# ECN for USB Power Delivery Specification Revision 3.2

Version 1.1, 2024-10

## Title: Dynamic Power Sources (DPS)

Figure 6-34 “Source\_Info Message”

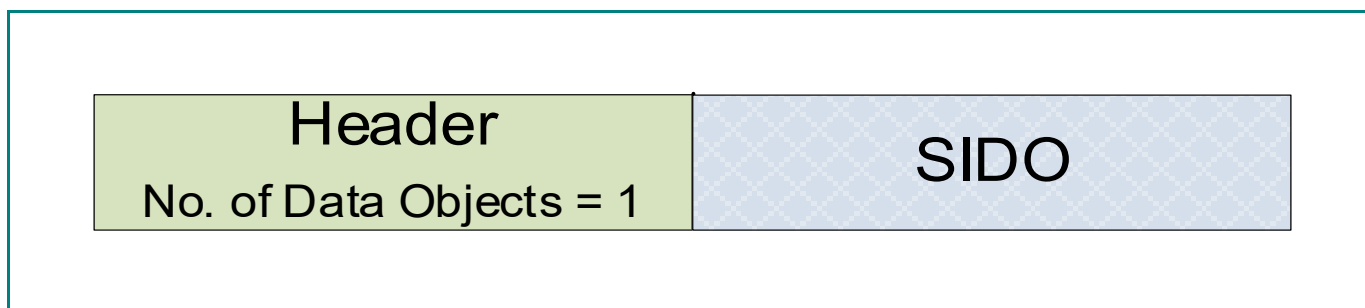
The **Source\_Info** Message **Shall** be sent in response to a **Get\_Source\_Info** Message. The **Source\_Info** Message contains **one two** Source Information Data Objects (SIDO).

The **Source\_Info** Message returns a SIDO whose format **Shall** be as shown in **Figure 6-1 "Source\_Info Message"** and **Table 6.52 "Source\_Info Data Object (SIDO)"**. The **Number of Data Objects** field in the **Source\_Info** Message **Shall** be set to **1-2**.

The **Port Maximum PDP**, **Port Present PDP**, **Port Reported PDP**, **DPS Port** and the **Port Type** are used to identify capabilities of a Source port.

Table 6.52 “Source\_Info Data Object (SIDO) 1”

Bit(s)	Field	Description
B31	<i>Port Type</i>	0 = Managed Capability Port 1 = Guaranteed Capability Port
B30...24	<i>Reserved</i>	<i>Shall</i> be set to zero
B23...16	<i>Port Maximum PDP</i>	Maximum Power the port will provide in 1W steps
B15...8	<i>Port Present PDP</i>	Power the port is presently capable of supplying in 1W steps
B7...0	<i>Port Reported PDP</i>	Power the port is actually advertising in 1W steps

Table 6.53 “Source\_Info Data Object (SIDO) 2”

Bit(s)	Field	Description
B31	Port Type	0 = Managed Capability Port 1 = Guaranteed Capability Port
B30	DPS Port	0 = Non DPS port 1 = DPS Port (Port Type in B31 <i>Shall</i> be set to 0)
B29...18	<i>Reserved</i>	<i>Shall</i> be set to zero and <i>Shall</i> be ignored.
B17...9	<i>Port Maximum PDP</i>	Maximum power the port will provide in 0.5W steps.
B8...0	<i>Port Guaranteed PDP</i>	Minimum power the port is guaranteed to always be able to provide in 0.5W steps.

Figure 10-xx “Example of a DPS temperature profile”

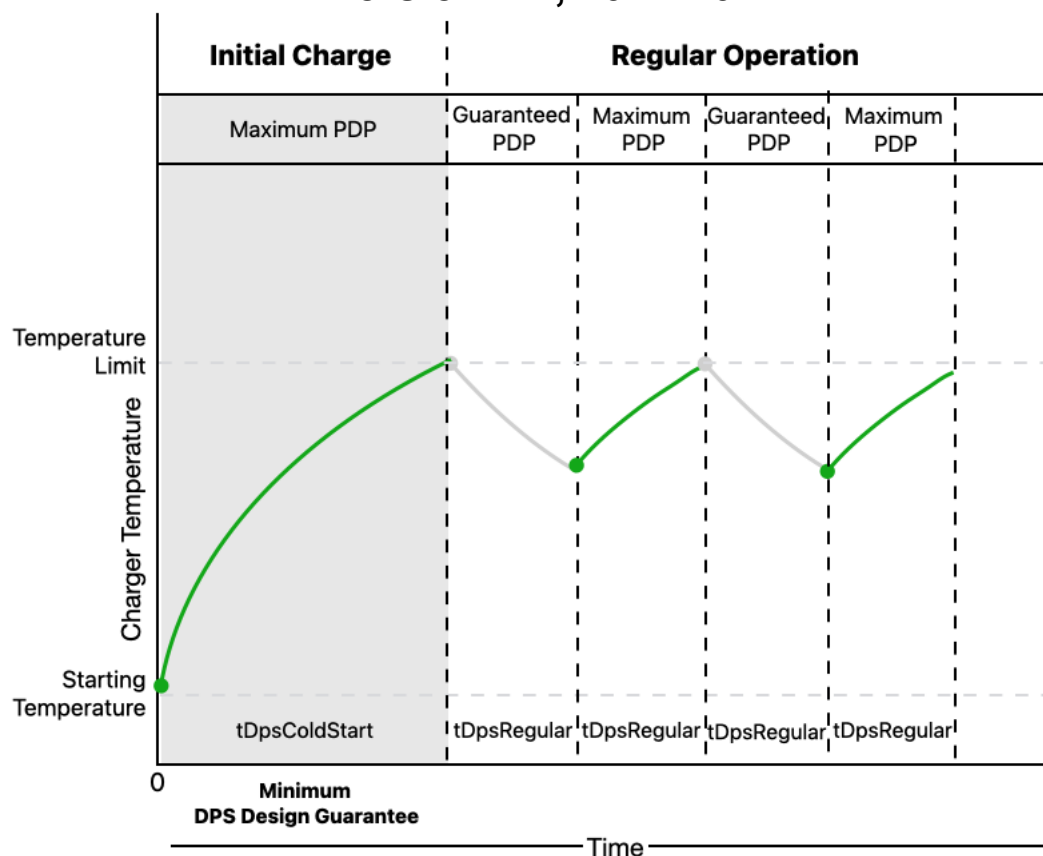
The Source power rules defined in *Section 10.2.2 “Normative Voltages and Currents”* and *Section 10.2.3 “Optional Voltages/Currents”* *Shall* apply to a DPS port, together with the following additional rules:

- A DPS Port **Shall** guarantee *tDpsColdStart* at Maximum PDP provided the following conditions are met:
  - The unit is starting from a cold start. This means the components inside the unit are at ambient temperature, and the ambient temperature **Should** be around 25°C.

- The Source port is not sourced by an internal Battery, per the Source Inputs Field of the Source Capabilities Extended message.
  - No other events arise that may require the Source to send new Source Capabilities (e.g. a new Request from the Sink).

- The Source **Should** not send updated Source Capabilities within *tDpsRegular* or *tDpsColdStart*, with the following exceptions:
  - If the Source just entered its first explicit contract with the Sink, it **May** send an updated Source Capabilities message, provided the Sink sets the Capability Mismatch bit, and the Source can increase the power offered.

- The updated Source Capabilities are due to sharing power with another port when the Source is a shared capability port.
  - Events arise that may require the Source to send new Source Capabilities (e.g. a new Request from the Sink).

- Parameters other than the temperature affect the Source Capabilities.
